REDSTONE GATEWAY PACKAGE I – LAKE F

Project No. 65-12-SP23

Addendum #1

MANDATORY PRE-BID MEETING

CS.4

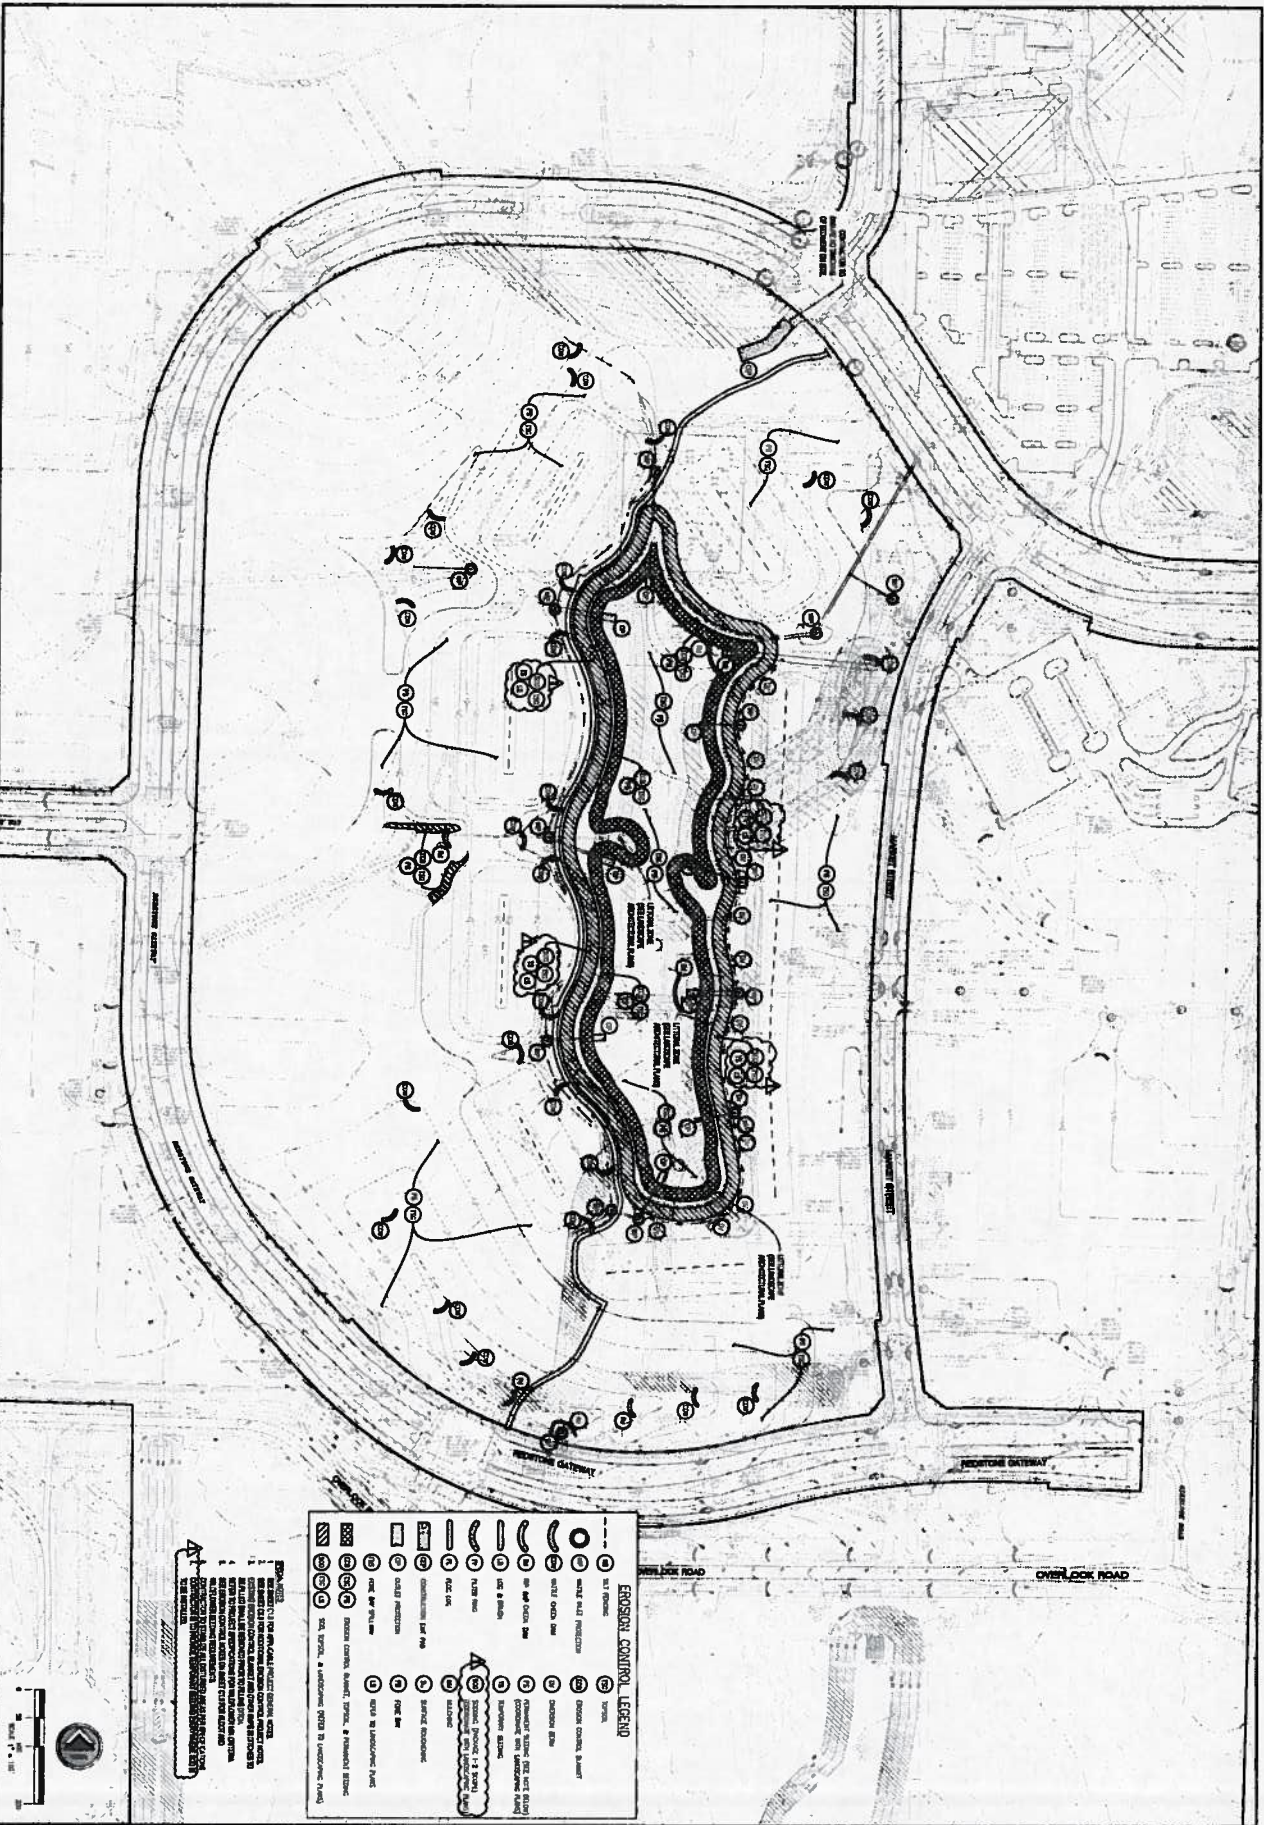
17. Q. What are the fill heights on the required box culverts as these are not shown on the plans and change drastically around Lake F?
A. Fill height design requirements were added to profiles on C5.3 and C5.4. See Addendum #1 drawings.
